Concord Middle School Value Management Log Poll Results

9/14/2022

The following slides summarize the Value Management polling completed via a Google Form between Monday, 9/12/22 and Wednesday, 9/14/22 by all 13 Voting Members of the Concord Middle School Building Committee.

Item # 9: Reduce advanced lighting controls from 100% addressable lights to 60% (-41,573).

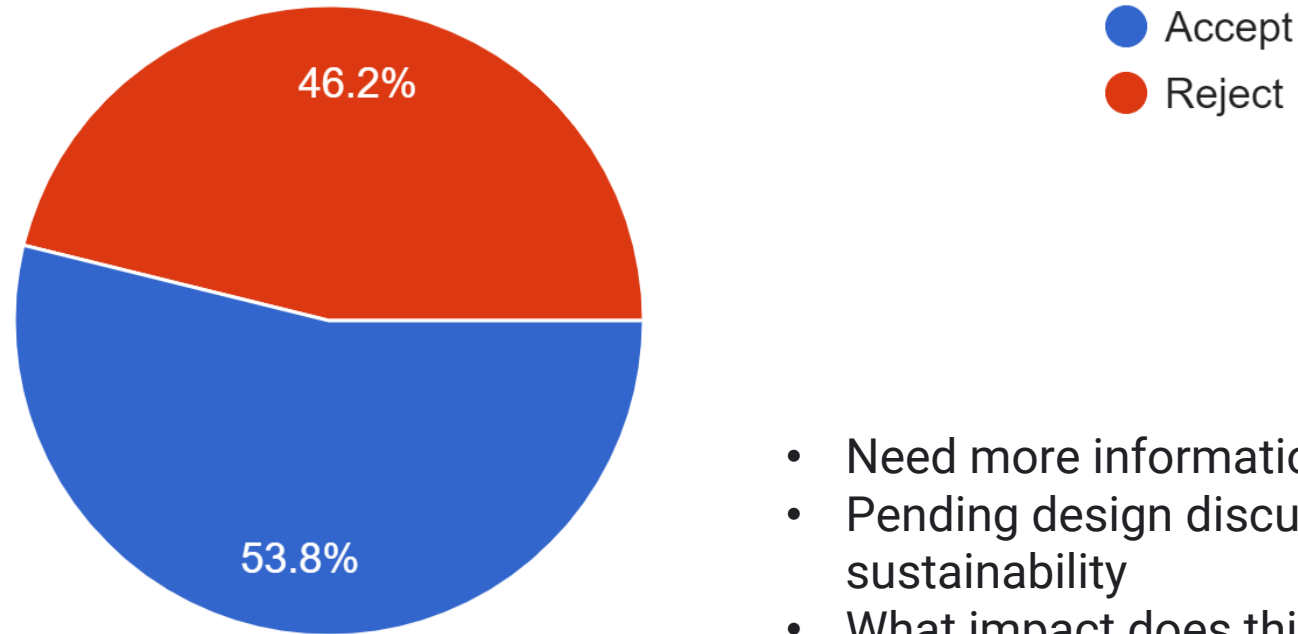
- Need more information
- Pending design discussion for adequate control and sustainability
- What impact does this have?
- Reject if sustainability subcommittee recommends

Item # 14: Replace 4,500 SF wood-look metal ceiling panel (MCP-1) with 2x2 ACP-1. (1/3 of the total 7,500 was removed in SD) (-189,422) .

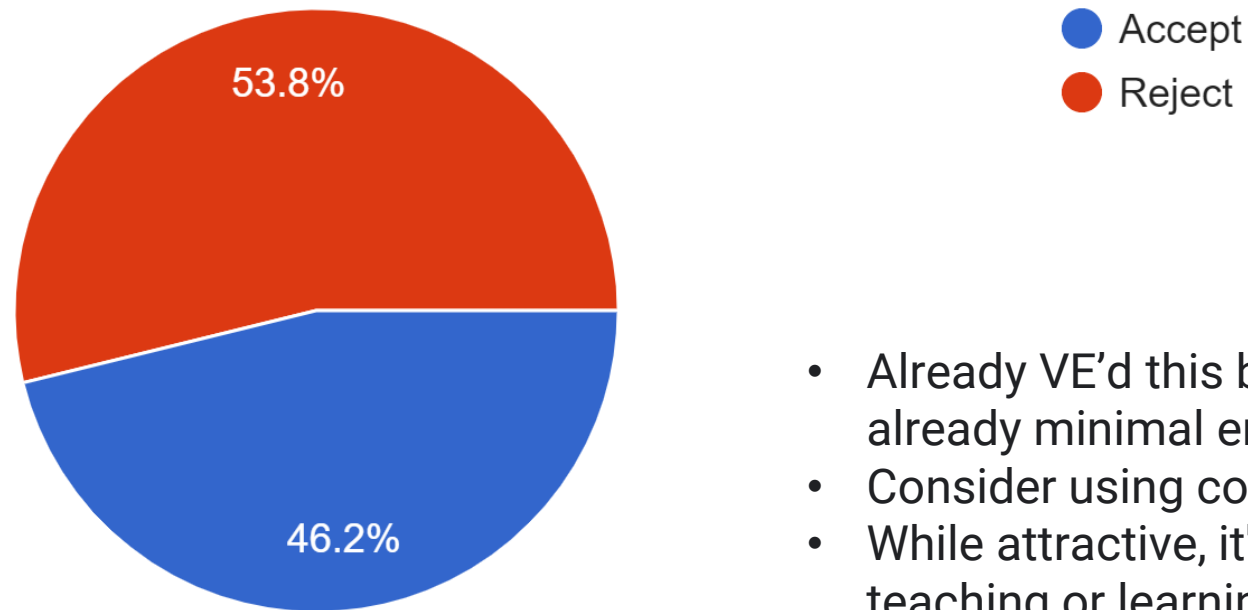
- Already VE'd this by over half. Keep the design as it is already minimal enough.
- Consider using contrasting color panels instead
- While attractive, it's beyond our scope and budget, no teaching or learning implications

Item # 30: Site: At south side of building at Dining Commons terrace: Remove 100 linear feet of retaining wall and guardrail, remove lawn terraces,...ent to patio and regrade. (BOD C-121) (-352,467).

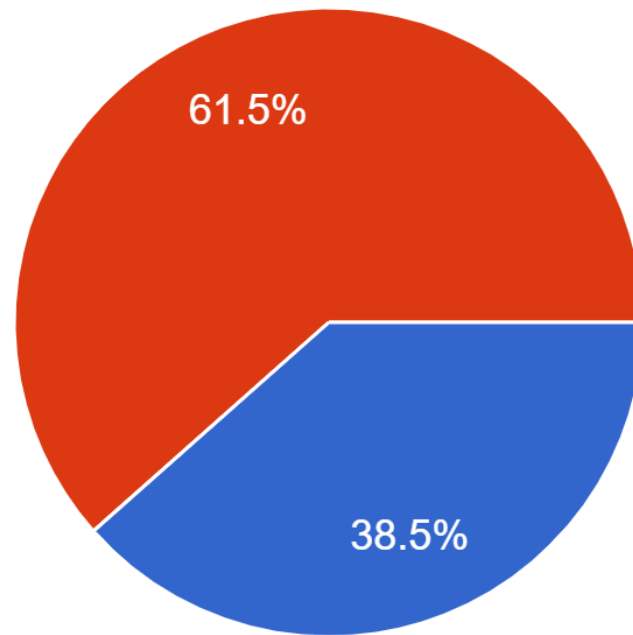
- Integral to connecting indoors to outdoors
- Student safety and connection to nature are primary concerns here.
- Will consider with more info
- Definitely, we have to - great number and variety of built and natural outdoor spaces will remain

Item # 43: Electrical: If PV canopies are installed in the North Parking lot, South parking Lot, and Walkway: Remove 4 Type BB light poles, 3 type AA1 Light poles, 5 Type CC Light poles. (-32,053).

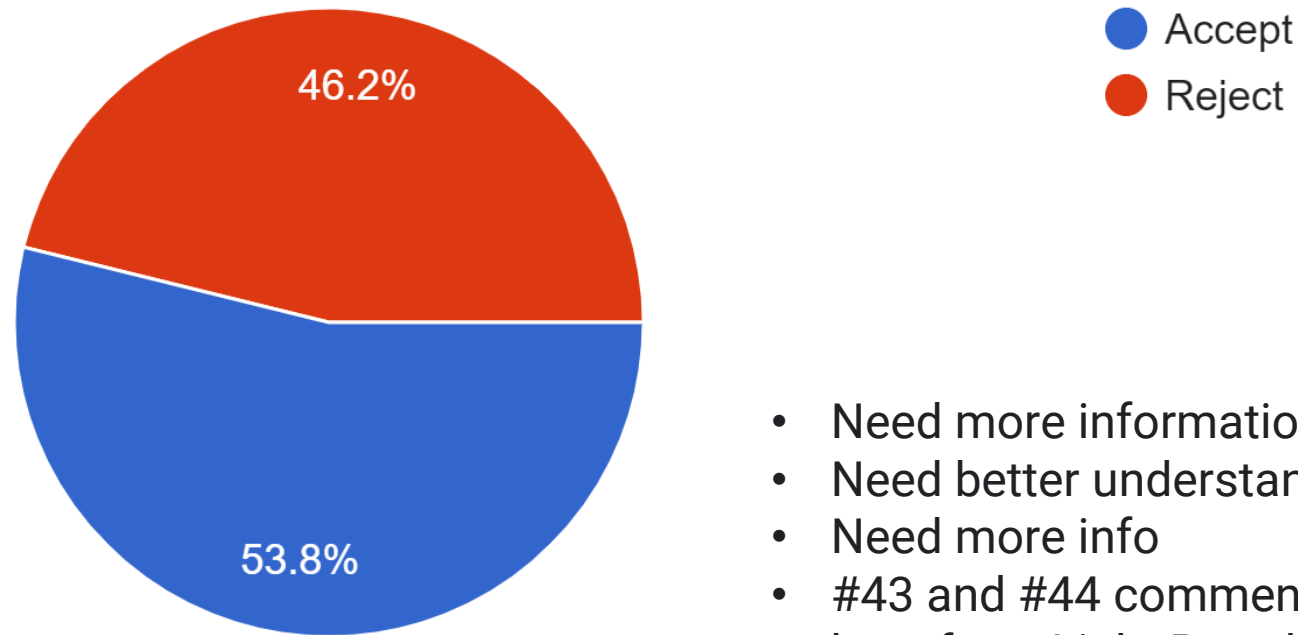
- Need more information from CMLP
- Need better understanding of impact on safety
- Need more info
- #43 and #44 comment: DON'T KNOW ENOUGH - let's hear from Light Board!

Item #: 46: FOR DISCUSSION: Reduce Construction Schedule by (2) months (-270,000).

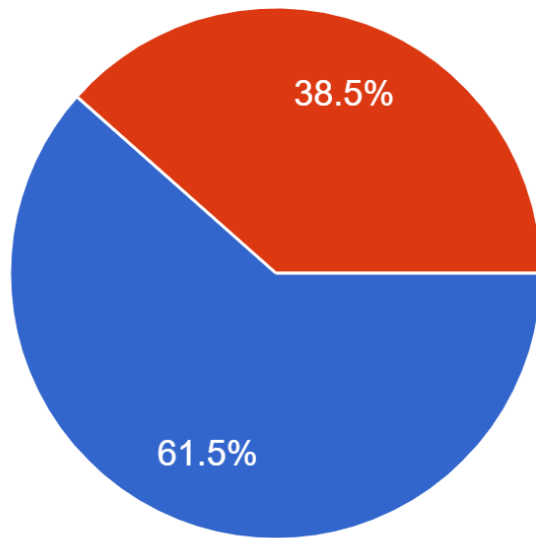
- Am not confident that Hill and SMMA can ensure that the Project will be complete in fewer than 24 months.
- Not recommended to assume a faster timeline is achievable in the current construction climate. By squeezing the schedule this puts additional pressure on the GC to make up the expense of expediting and overtime that would be needed to achieve the schedule (delay claims and change orders). By providing sufficient time to the GC, we can avoid a schedule crunch at the end of the job and improve the likelihood of on-time delivery of a quality product. Quality will suffer with a condensed timeline.
- Construction projects are facing labor shortages and material supply delays, so it's not reasonable to expect that everything will go perfectly.
- What are the risks?
- Unrealistic to assume we could do this

Item # 57: Reduce ceramic wall tile in toilet rooms to 8' on wet walls only. Epoxy paint on all other walls (-274,543).

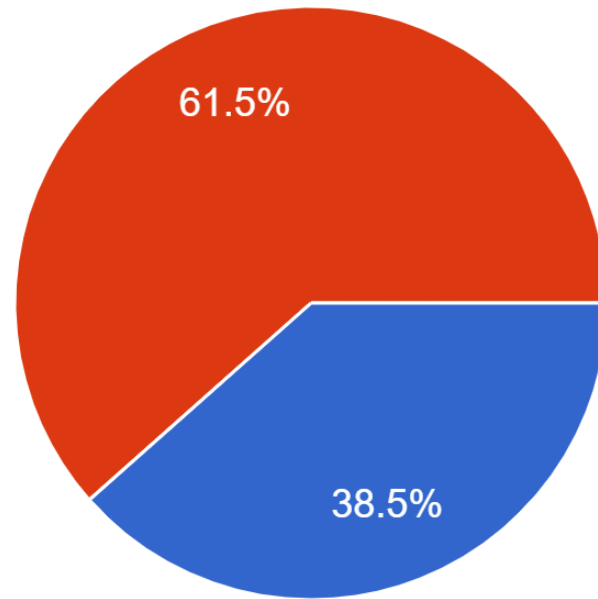
- Should go to 8' on all four walls
- Partly accept. Need more information about cost-effective alternatives to additional tiles
- Not advisable in a middle school setting.
- I realize that there might be some maintenance impact of reducing the amount of tile, but \$275,000 worth? The tradeoff seems worthwhile given our budget constraints.
- High School has 6" and it is acceptable

Item # 60: Eliminate lightning prevention system (-69,720).

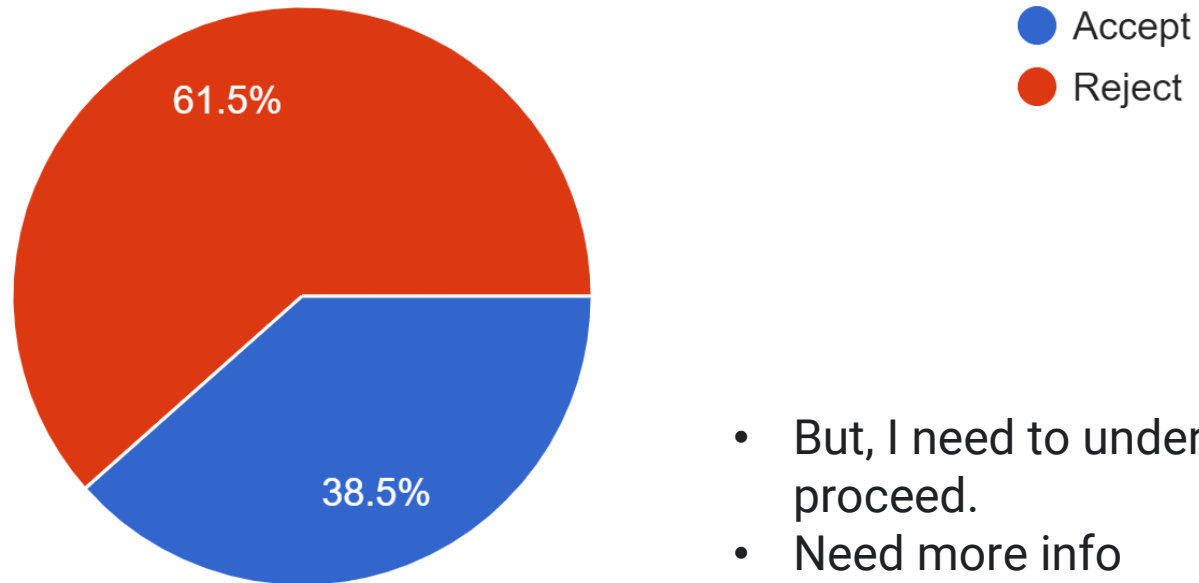
- But, I need to understand this system before we proceed.
- Need more info
- Not a wise reduction in scope
- I need more info on this one
- Need more info
- Don't know about this unless and until we examine it further
- What exactly is this system?

Item # 63: Reduce height of Gymnasium to minimum clearance allowed by MIAA for basketball - Approx 5'-0" ft (-104,332).

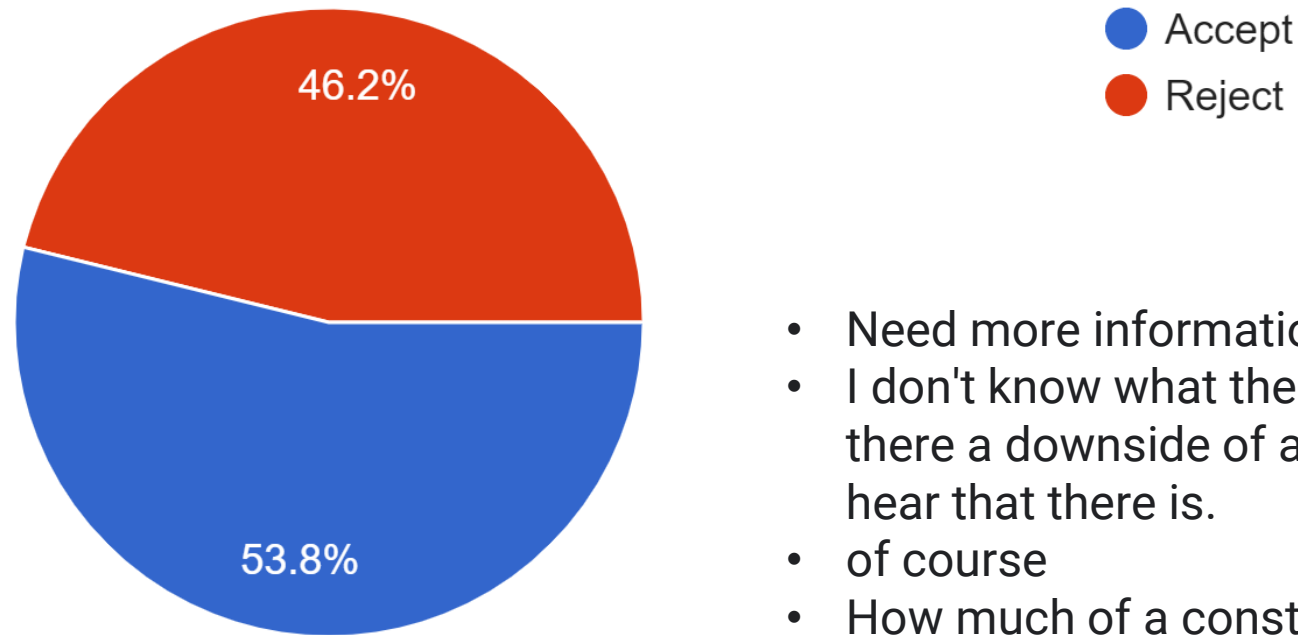
- Need more information
- I don't know what the tradeoffs are for this item - is there a downside of a lower ceiling? Accepting until I hear that there is.
- of course
- How much of a constraint is this reduction?

Item # 66: Reduce Auditorium and Specialty space AV systems by 25% (-265,271).

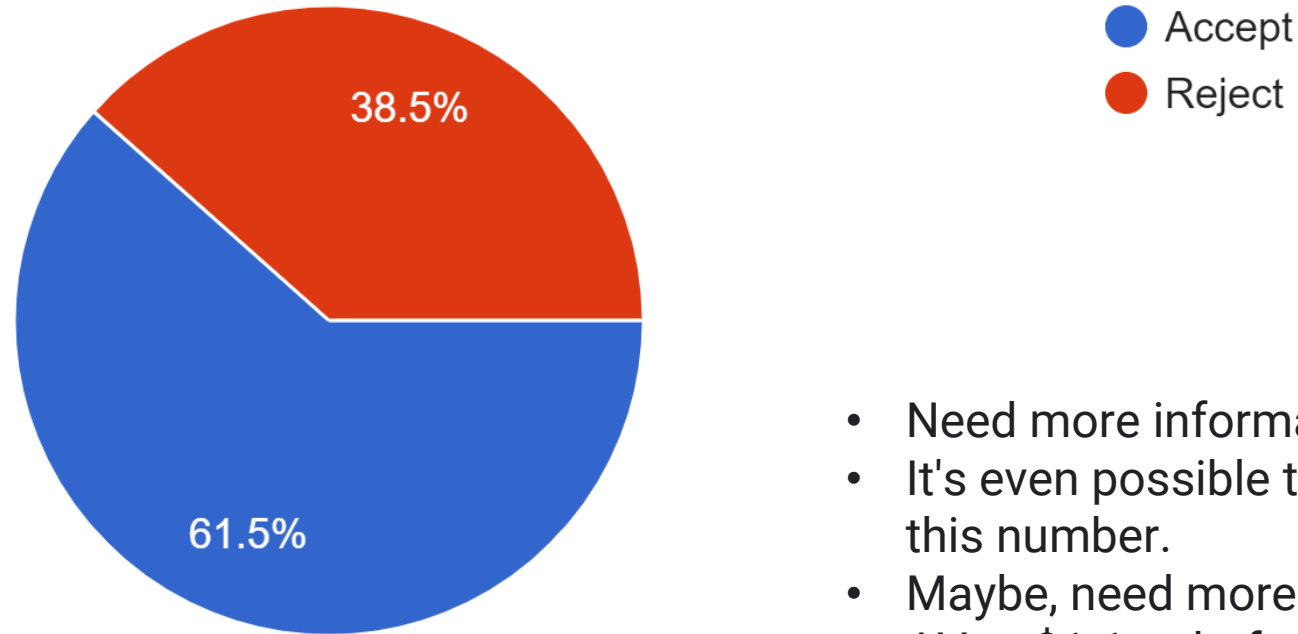
- Need more information
- It's even possible that more could be taken out of this number.
- Maybe, need more info
- AV at \$1.1 m before F&F, in light of all the existing portable equipment, is not necessary
- Maybe not all 24%? Maybe only 15%? \$1M on AV equipment seems like a lot of money.

Item # 67: Replace granite curbing at straight sections with precast concrete curbing (-67,438).

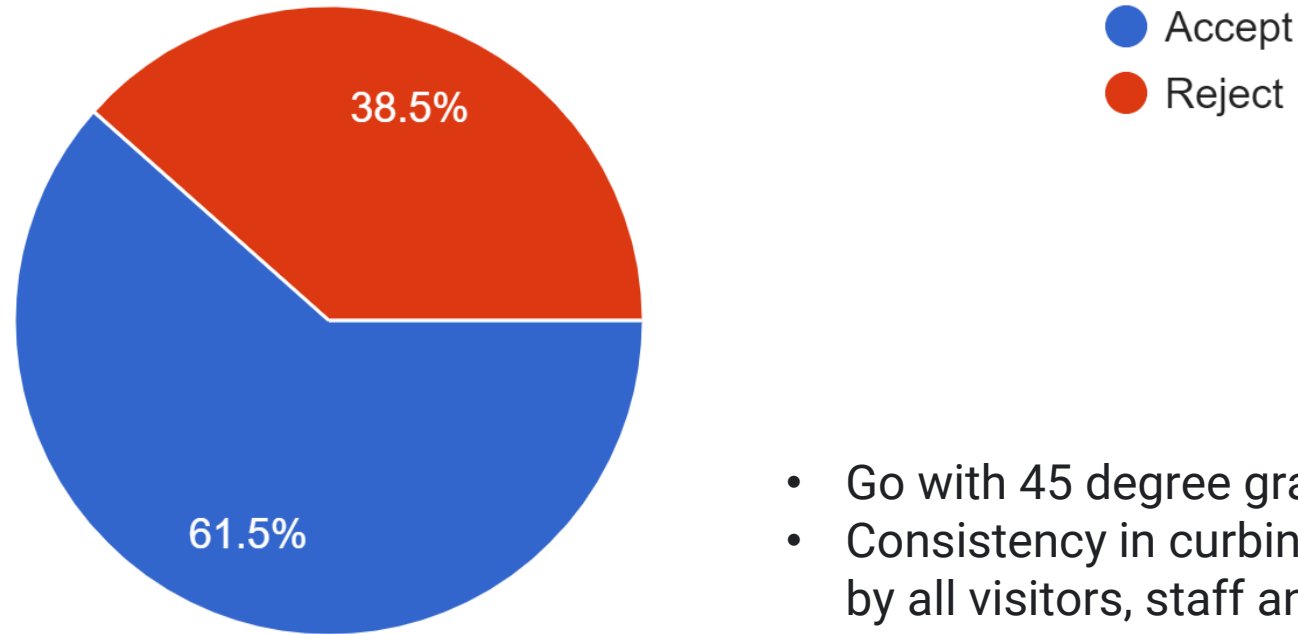
- Go with 45 degree granite, not vertical.
- Consistency in curbing materials will be apparent by all visitors, staff and faculty.
- Higher maintenance
- Granite more attractive but unnecessary here

Item # 69: Eliminate full height built-in shelving at Media Center (all shelving to be FF&E)
(-75,133).

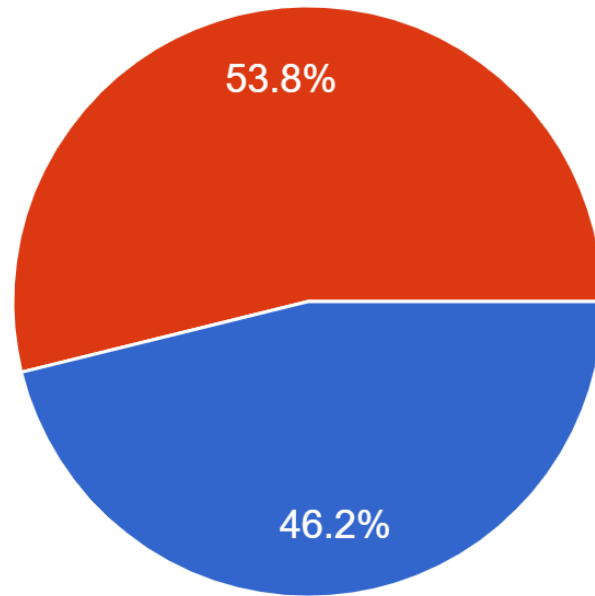
- Reduce to 5'.
- Never seem to have enough storage
- Build to future non-digital collection needs

Item # 72b: Reduce millwork display cases by 50% (-77,376).

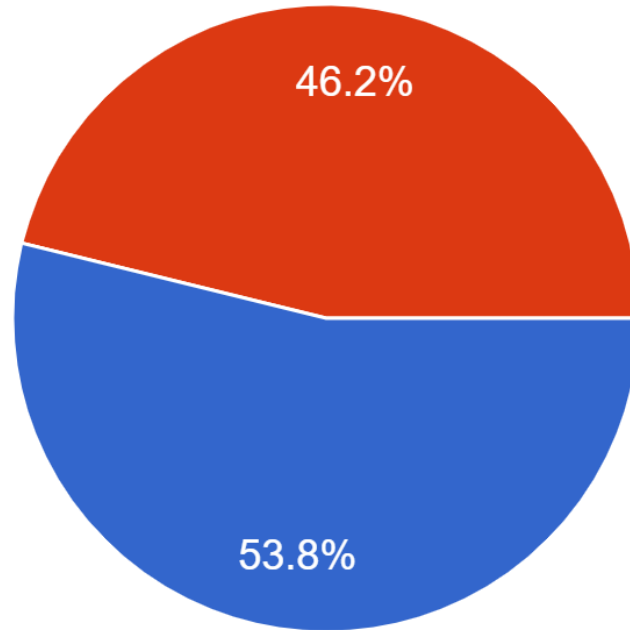
- Taken in lieu of 72a
- What is the impact?

Item # 74: Rough in Only for Sound Field Systems in Classrooms- Systems and Speakers by FF&E (Teacher Amplification) (-125,874).

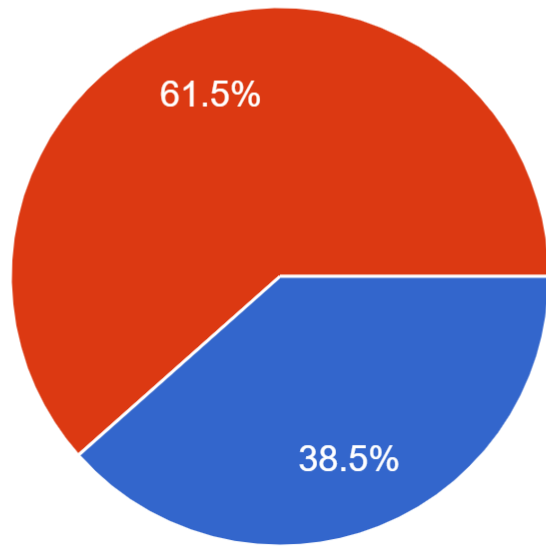
- Need to understand issue with portable system.
- Need more information
- Does this affect kids with hearing loss
- Unfamiliar with this item and would like clarification.
- \$3500/classroom sounds high for a system like this; are there alternatives?
- Maybe, need more info
- Discuss within larger AV \$1.1 budget, and consider our portable systems each teacher has

Item # 75: Eliminate roof davit and associated structure (-29,060).

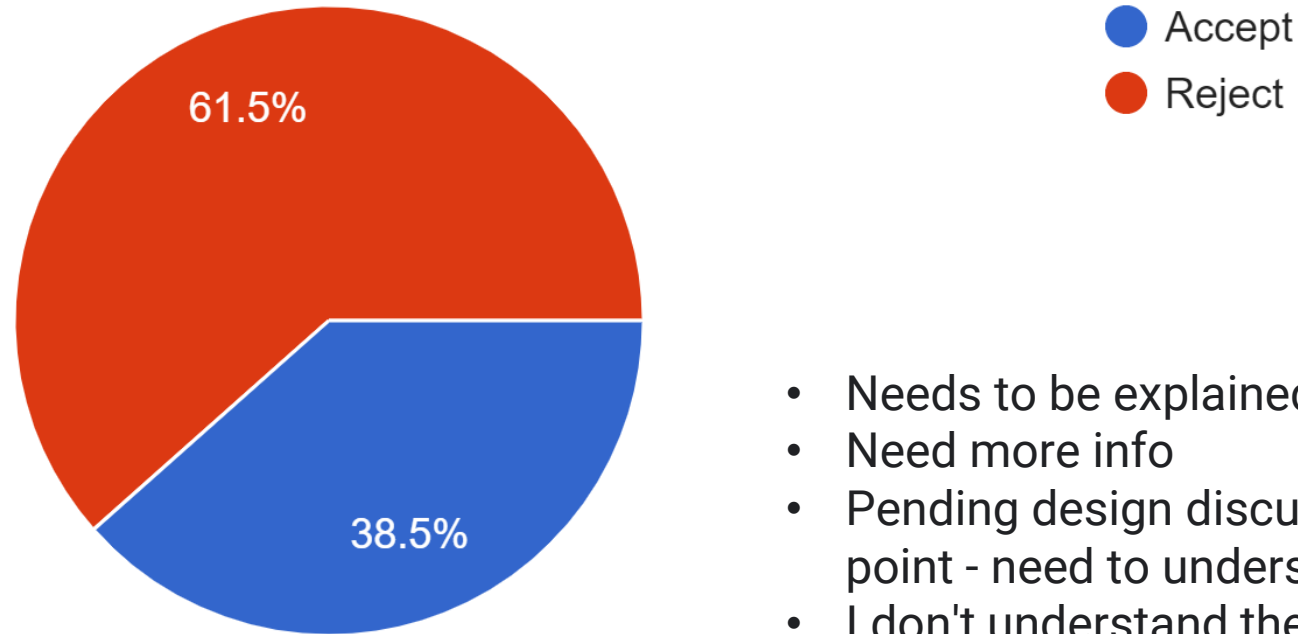
- Needs to be explained.
- Need more info
- Pending design discussion of the need for this anchor point - need to understand alternative access plan.
- I don't understand the implications of doing this
- Not sure what this is
- PLEASE EXPLAIN

Item # 76: Eliminate green screen/cable trellis (-58,100).

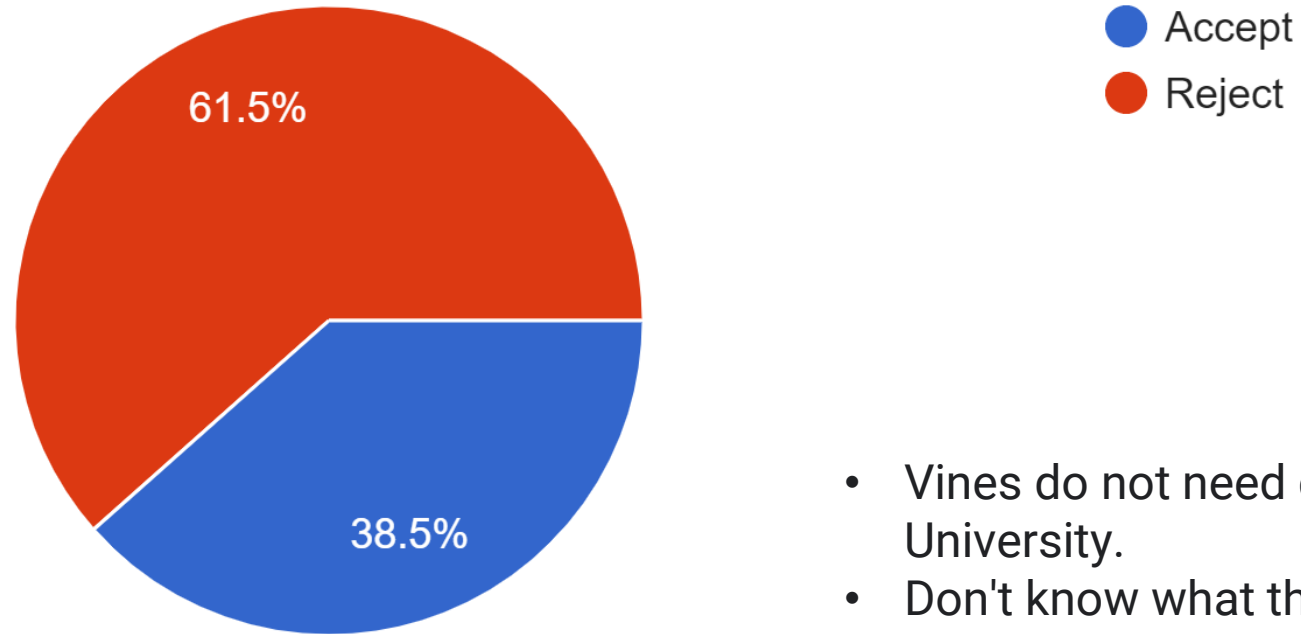
- Vines do not need cables. Check out Harvard University.
- Don't know what the impact would be on ed plan
- Need more info
- Ivy will grow nicely without it

Item # 77: Simplify main entry canopy design by 50% (-59,203).

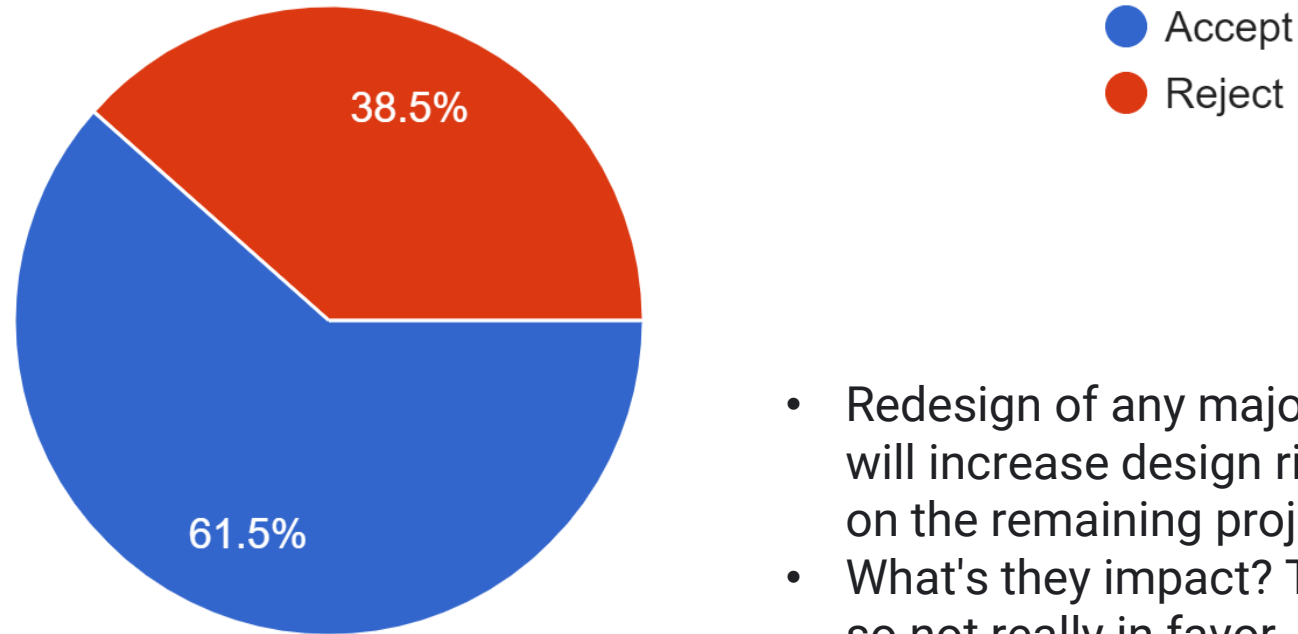
- Redesign of any major component at this stage will increase design risk (design contingency \$) on the remaining project.
- What's the impact? This is the first thing you see so not really in favor
- Other schools fare well with no canopies
